# WASHINGTON UNION STATION

MAIN HALL PROJECT

SECTION 106 ASSESSMENT OF EFFECT 2010-2012  
DRAFT AUGUST 2012

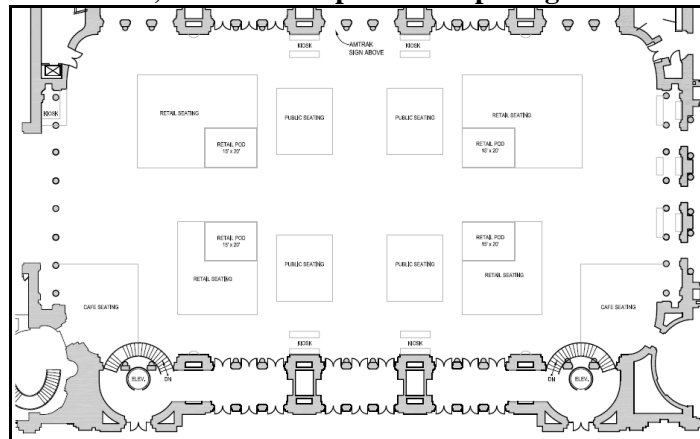
This design study does not involve any destruction of historic fabric. It restores the north-west pedestrian axis, and it completely removes the vertical central obstruction. The newly designed kiosks that appear in the Main Hall are removable, which allows for even more expansion of pedestrian space and open space for private events. The use of wood for balustrades and signage in the center of the hall is consistent with Union Station's historic materials palette.

Design Issue	Build Design Study 9
Center Café	None

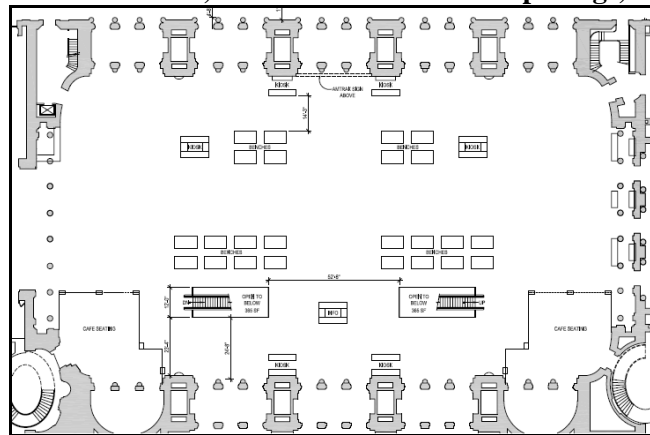
This design study limits adverse effect as it does not involve any destruction of historic fabric. It further works to minimize and mitigate other adverse effects by restoring both the north-south and east-west pedestrian axes through the Main Hall. It completely removes the Central Café obstruction, restoring full spatial volume and allowing for optimal sightlines and navigation. The floor penetrations at the northeast and northwest are minimized to 200 square feet each, and the train schedule signage is returned to its historic location on the north wall.

There are significant efforts to avoid, minimize, and mitigate adverse effects in this iteration of the design, but floor penetrations and permanent alterations to accommodate escalators will change the historic character of the Main Hall. Further, the overall materials palette of this design study is in glass and steel, which is inconsistent with the wooden accents historically used at Union Station. This design study's commercial viability is weak due to the lack of a café.

**Build Design Study 11a**  
**Center Café moved, escalators in two small openings,**  
**field of historical benches, LMUs added**

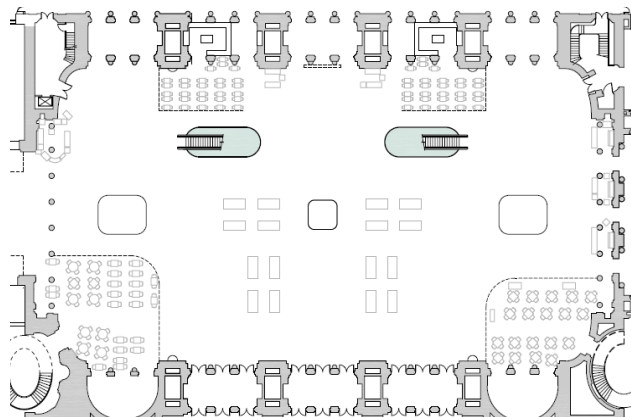
This design study avoids adverse effect as it does not involve any destruction of historic fabric. It also minimizes and mitigates several potential adverse effects by restoring both the north-south and east-west historic axial pedestrian axes through the Main Hall. It completely removes the Central Café obstruction, restoring full spatial volume and allowing for optimal sightlines and navigation. The newly designed kiosks, benches, and signage over the escalators are based on historic precedent and are removable, which allows for expansion of pedestrian space and open space for private events. The escalators in the Main Hall will operate in the opposite direction of the existing escalators in the Train Concourse to the north, improving pedestrian traffic flow and the commercial viability of the design. Additionally, the train schedule signage is returned to its historic location on the north wall. Finally, the design's material palette is consistent with Union Station's 1920s appearance.

Only minor adverse effects remain in this iteration of the design. The openings in the floor alter the historic character of the space and the installation of escalators is a permanent change in the layout of the room. The wooden balustrades surrounding the openings for the escalators minimize the visibility of the penetrations but also decrease visibility between the Main Hall and Lower Level, and the wood signage over the escalator openings may diminish visibility. The re-introduction of backed benches, designed to be very similar to the original benches, could encourage loitering of unwanted visitors and would impede safety enforcement. In addition, the re-introduction of furniture designs based on the appearance of the Station in the 1920s could lead to confusion over authenticity.

**Build Design Study 12**  
**Center Café moved, escalators in two small openings; LMUs added**

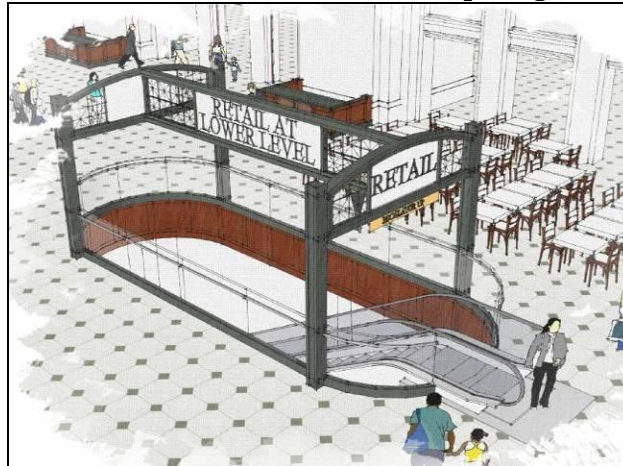
This design study avoids adverse effect as it does not involve any destruction of historic fabric. It also minimizes and mitigates several potential adverse effects by restoring both the north-south and east-west historic axial pedestrian axes through the Main Hall. It completely removes the Central Café obstruction, restoring full spatial volume and allowing for optimal sightlines and navigation. The newly designed kiosks and signage over the escalators are removable, which allows for expansion of pedestrian space and open space for private events. The escalators in the Main Hall will operate in the opposite direction of the existing escalators in the Station concourse to the north, improving pedestrian traffic flow and the commercial viability of the design. Additionally, the train schedule signage is returned to its historic location on the north wall. Finally, the design's material palette is consistent with other elements throughout Union Station, such as those in the Shopping Concourse.

Only minor adverse effects remain in this iteration of the design. The openings in the floor alter the historic character of the space and the installation of escalators is a permanent change in the layout of the room. By incorporating glass into the designs, however, as much visibility as possible is maintained.
